APPLICATION NO: 13/00756/FUL		OFFICER: Mrs Wendy Hopkins
DATE REGISTERED: 10th May 2013		DATE OF EXPIRY : 9th August 2013
WARD: Leckhampton		PARISH: LECKH
APPLICANT:	Martin Scott Homes	
LOCATION:	Leckhampton Industrial Estate, Leckhampton Road, Cheltenham	
PROPOSAL:	Demolition of existing buildings and residential development comprising the construction of 28 dwellings

ADDITIONAL REPRESENTATIONS 11th – 13th November 2013

Demolition of existing buildings and residential development comprising the construction of 28 dwellings. Leckhampton Industrial Estate, Leckhampton Road, Cheltenham, Gloucestershire, GL53 0AL, by Martin Scott Homes (205 Leckhampton) Ltd.

ANALYSIS OF THE PROPOSED DEVELOPMENT AT 205 LECKHAMPTON

49 Collum End Rise First Floor

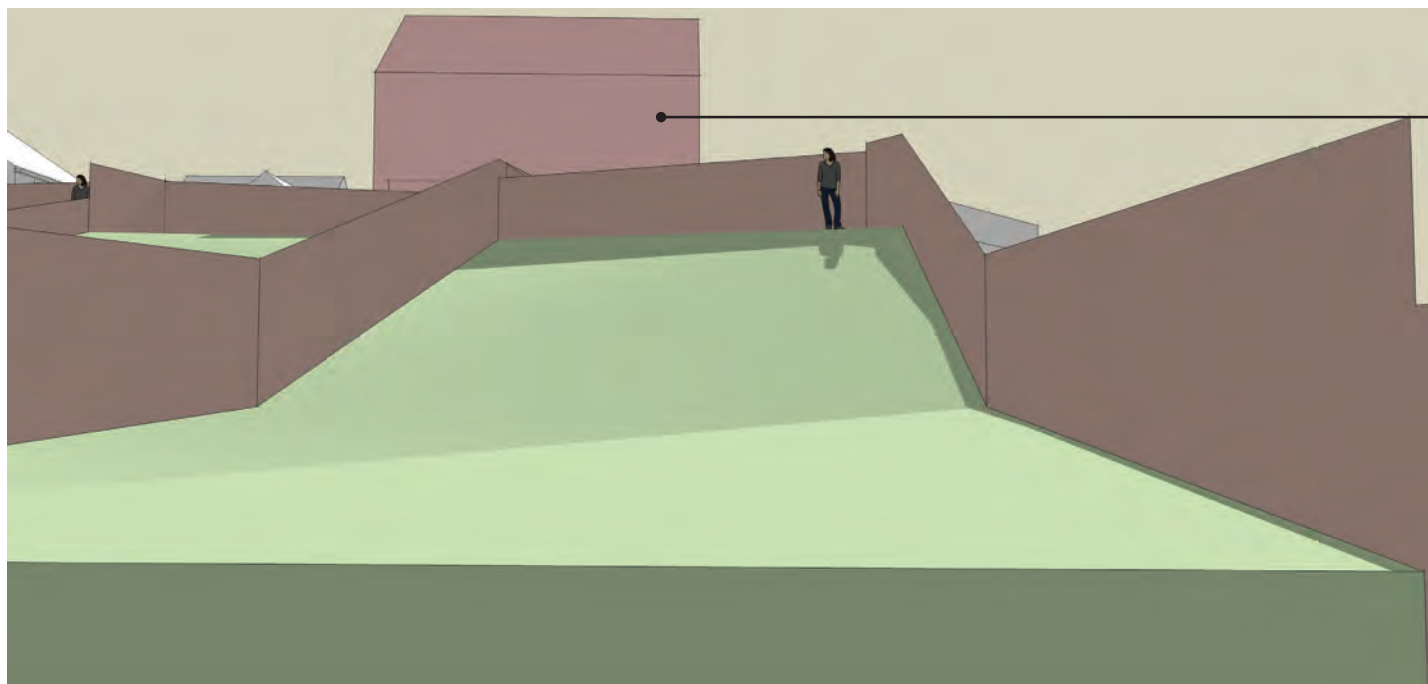
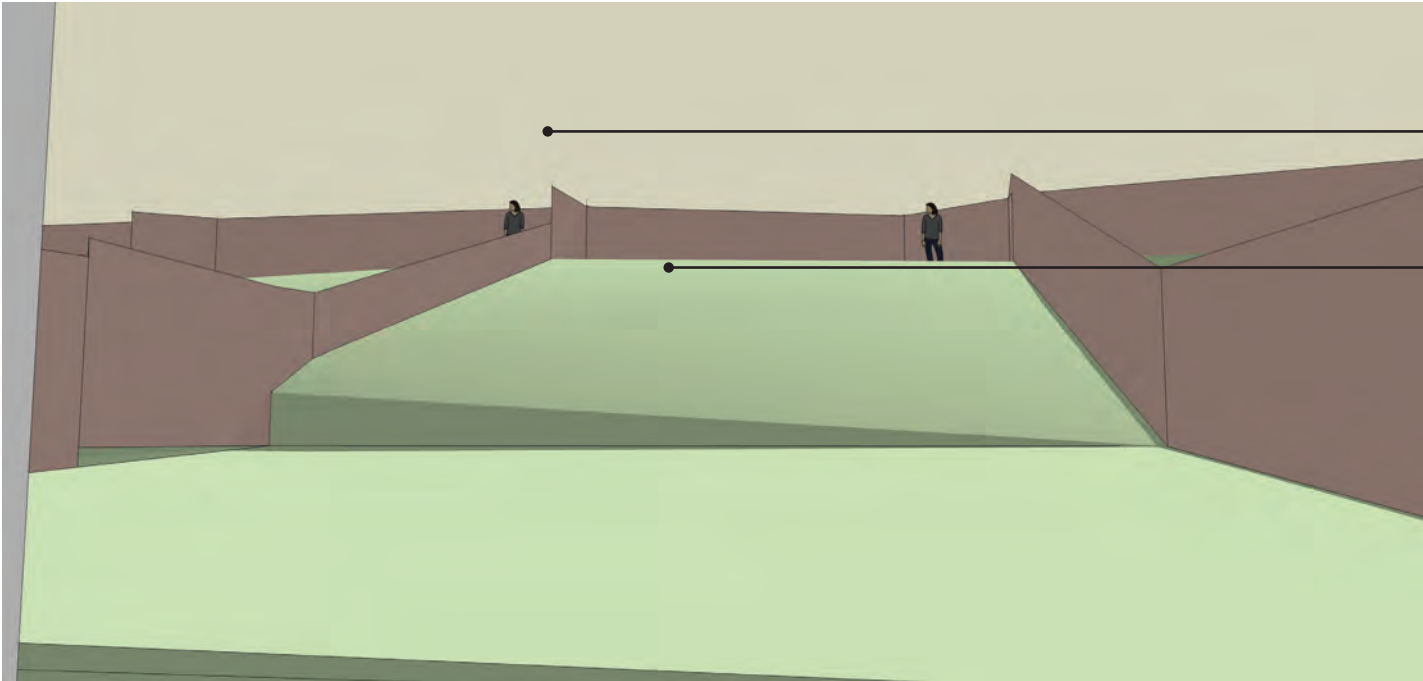
Proposed 3 storey property has a significant visual impact due to scale of the proposals and elevated site.

The Ground Floor of the proposed house (plot 17) is 5.01m above the existing patio level adding nearly two storey to the effective height.

The proposed house has a significant presence at the end of the garden.

51 Collum End Rise Ground Floor

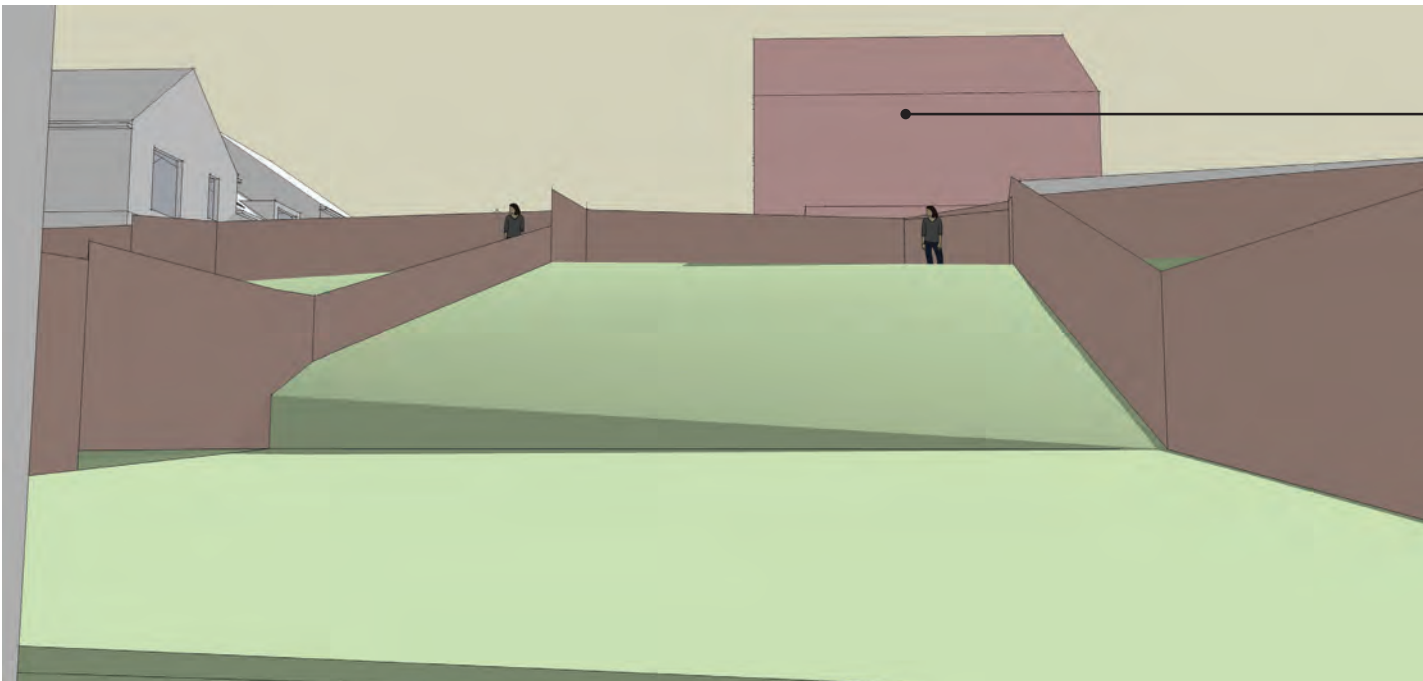
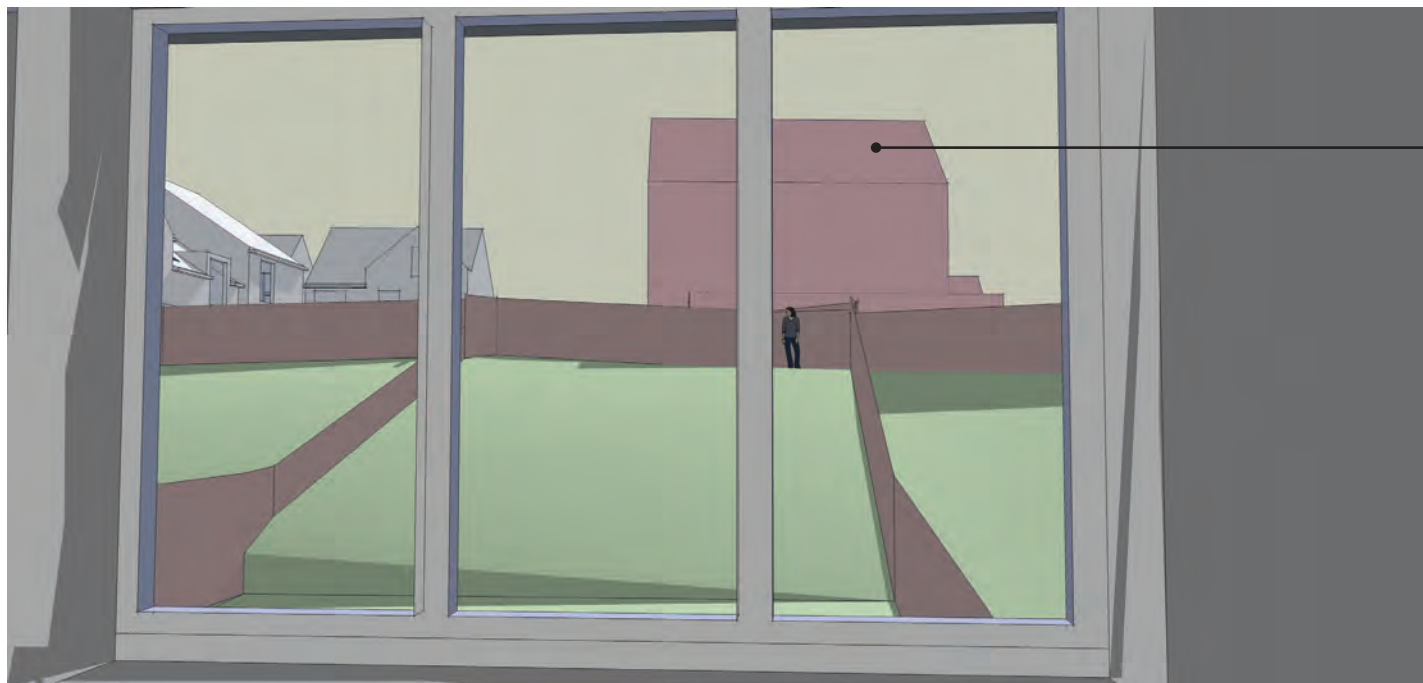
Due to the proposed houses being 3 storey the effective height visible over the proposed 1.8m high fence is significant. Added to the 5.01m elevated level of the proposed ground floor makes for a proposed development that dominates the skyline.

With the proposed Ground Floor 5.01m above the patios and a 6m high side elevation the effective height of the eaves is over 11.01m. This is nearly equivalent to a 4 storey building to the eaves with a ridge height 13.9m above the existing patios level.

53 Collum End Rise First Floor

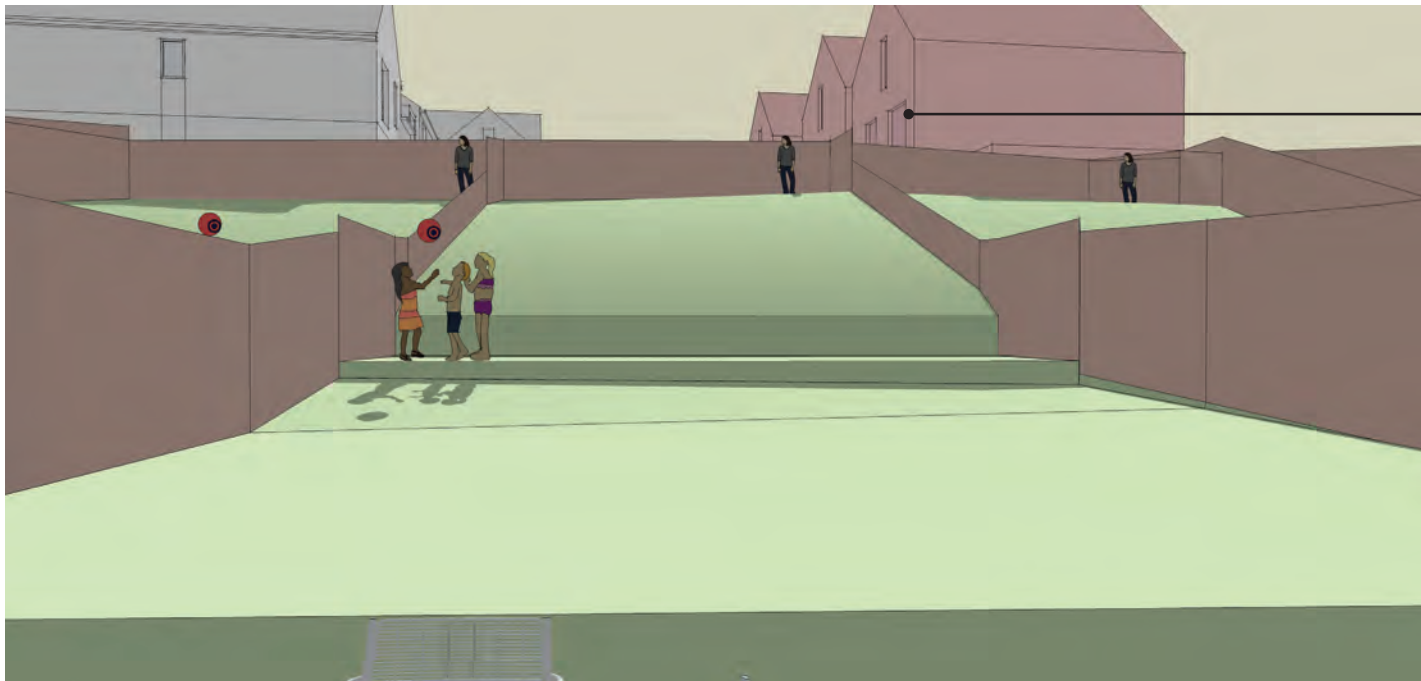
Proposed 3 storey properties have a significant visual impact due to scale of the proposals and elevated site. The oblique view of the gables adds to the mass and visual impact.

The Ground Floor of the proposed house (plot 17 and 18) is 4.71m above the existing patio level adding nearly two storey to the effective height.

Oblique views of the upper 2 floor gives the perception of overlooking and directly effects privacy. This will be exacerbated at night when large elevated windows are lit.

55 Collum End Rise Ground Floor

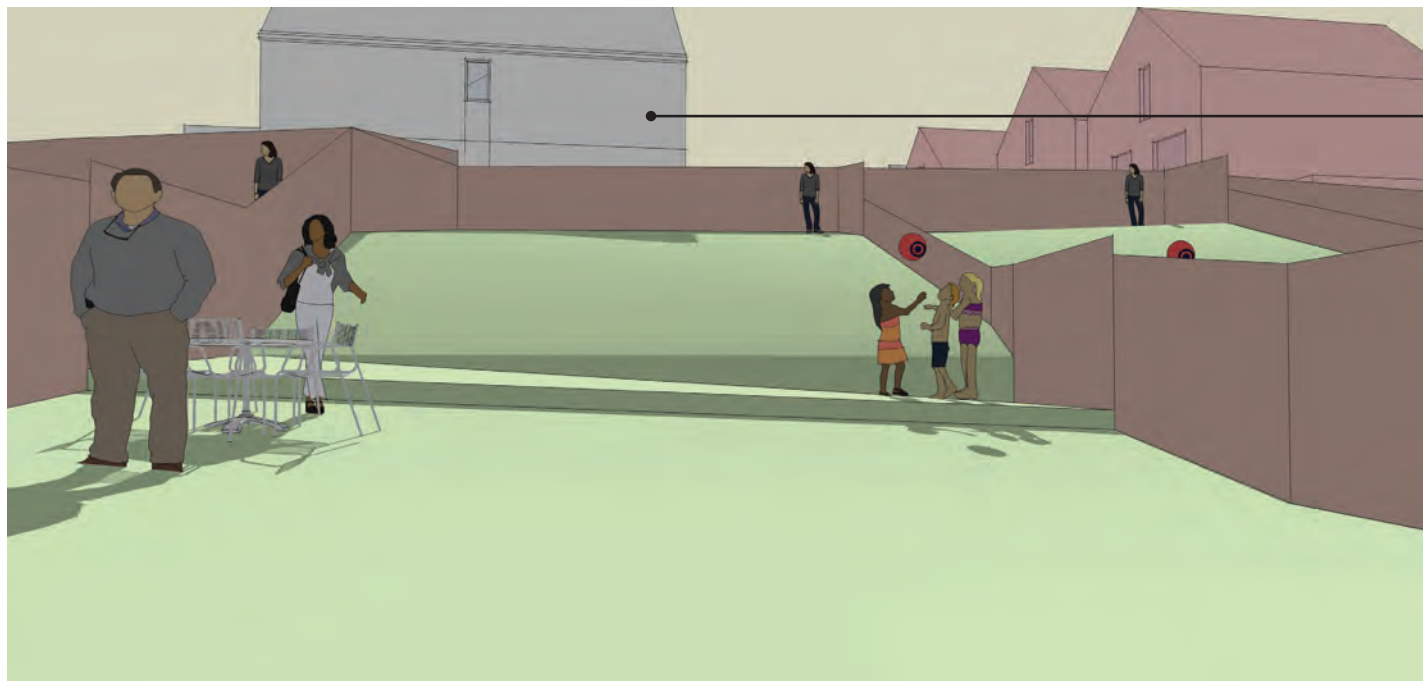
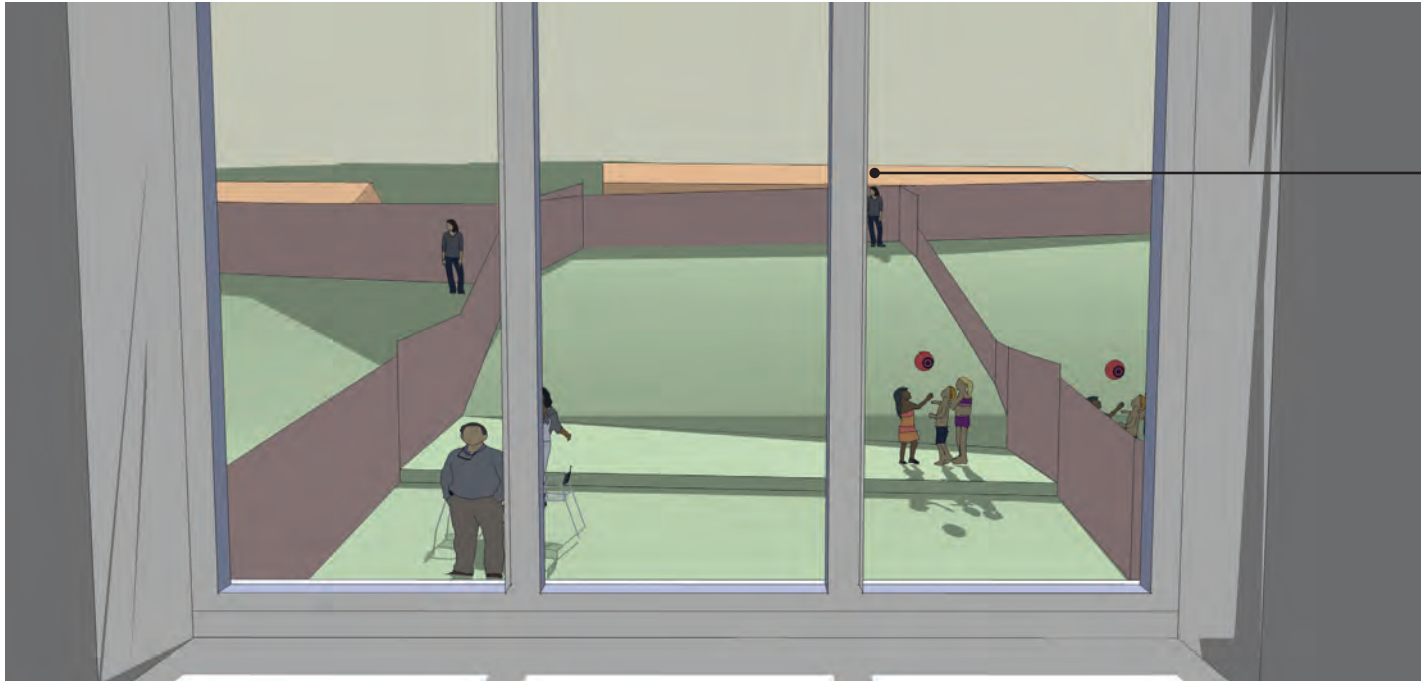
Over a storey of the proposed properties are visible over the proposed 1.8m high boundary fence.

With the proposed Ground Floor 4.71m above the patios a 5m high side elevation the effective height of the eaves is over 9.5m. This is equivalent to a 3 storey building to the eaves.

The scale of the proposed house will be overbearing and have a detrimental impact on the use of the garden, outlook from the property and amenity of the occupants.

55 Collum End Rise First Floor

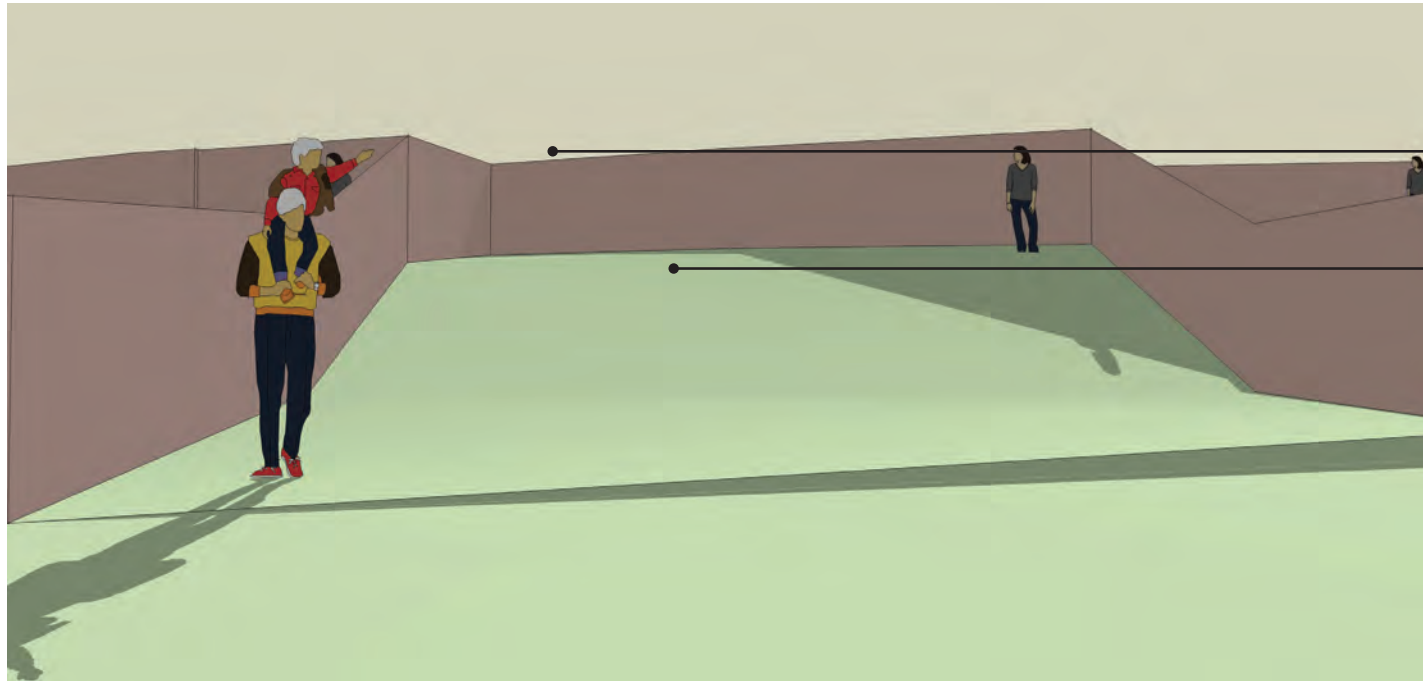
Proposed properties have a significant visual impact due to scale of the proposals and elevated site.

The Ground Floor of the proposed house (plot 18) is 4.71m above the existing patio level adding nearly two storey to the effective height.

The proposed house is exactly due south and the side elevation blocks more than 50% of the end of the garden. In addition to the overbearing this will create significant overshadowing of the garden and house all year and especially during the winter months when sun light is so valuable.
